**Mixed Use Development
78-90 Old Canterbury Road, Lewisham**

MP 08_0195 MOD 5

Modification to approved Concept Plan

Director-General's
Environmental Assessment Report
Section 75W of the
Environmental Planning and Assessment Act 1979

Figure 3: Agency's depiction of approximate location of stormwater works

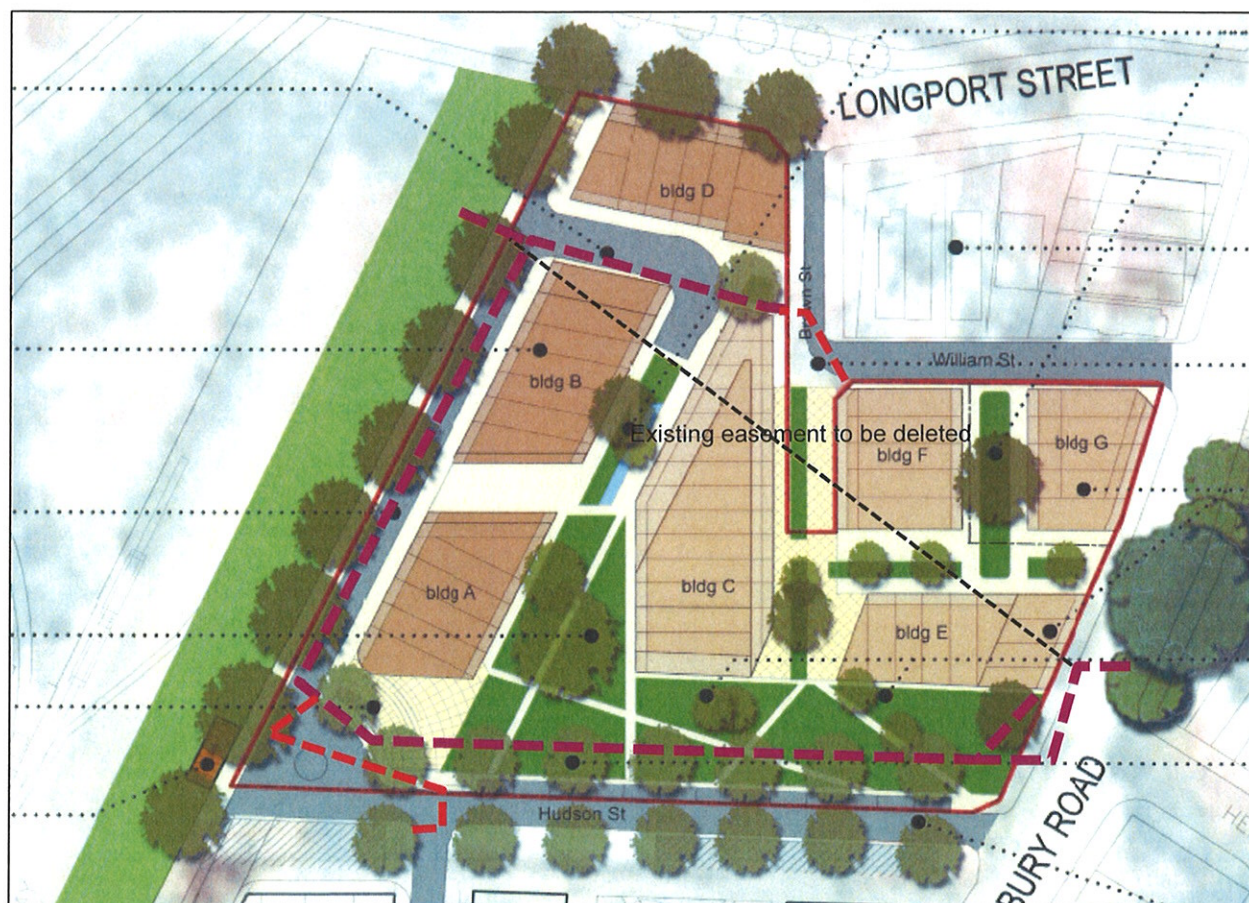
The proponent seeks a 50% offset for all stormwater works. The offsets are sought on the basis that the works will increase the capacity of the system, benefiting properties outside of the development site. The proponent argues that the development will only contribute 6% of stormwater flows into the pipes and on this basis an offset should be provided. In addition, the proponent advises that the works in McGill Street are of no benefit to the development, but rather will enable the redevelopment of other land to the south of the site. The Brown and William Street works will significantly increase the capacity of the system, benefiting properties outside of the development site.

Council argue that no offset should be provided on the grounds that the proposed stormwater works are a direct result of the proponent's design and would not otherwise be required to be carried out. Council also advises that as its s94 Contributions Plan does not levy for stormwater infrastructure, any offset would be at the expense of planned works for other purposes under the s94 plan, resulting in an inequitable outcome and undermining the operation of the s94 plan as a result of loss of anticipated funds.

In its review, Evans and Peck advised that the fact that the proposed development will only contribute to 6% of flows in major storm events is not relevant. The site's location dictates that stormwater will drain towards it. Therefore if the proponent wishes to develop the site and provide appropriate amenity it will need to provide drainage, including amplification of the existing system to accommodate flows upstream of the site. The purpose of the diversion of

While Evans and Peck considered that there may be some (limited) merit in the Council bearing a marginal portion of the cost of the Brown Street works due to significant improvements in this area, there was not a sufficient demonstration of a public benefit in relation to the remainder of the works that would warrant any offset.

MCA considered the report by Evans and Peck as well as the arguments put forward by the proponent and Council. MCA found that none of the proposed stormwater works constitute a material public benefit that would warrant an offset against s94 contributions. Rather, the works constitute the usual types of ancillary works expected from large scale development and are expenditure related to private development.

The agency has considered the arguments put forward by the proponent, Council, Evans and Peck and MCA. It is considered that whilst substantial, the proposed stormwater works are typical of the kinds of works often carried out as ancillary to development of this scale as they are necessary to facilitate the proposed development, to allow for construction of basements and new buildings, to protect the site from flooding, improve amenity for future occupants of the site and to ensure the development does not result in any unacceptable flooding impacts. The agency accepts the MCA review that the proponent has not demonstrated that the works go beyond what is reasonably required to develop a site that is affected by upstream flows to and ensure it does not result in any flooding impacts. Any public benefit arising from the works would be incidental to the primary purpose of facilitating the proposed development. As such, the agency considers that it is not appropriate that the proponent receive an offset for the works against the required s94 contributions.
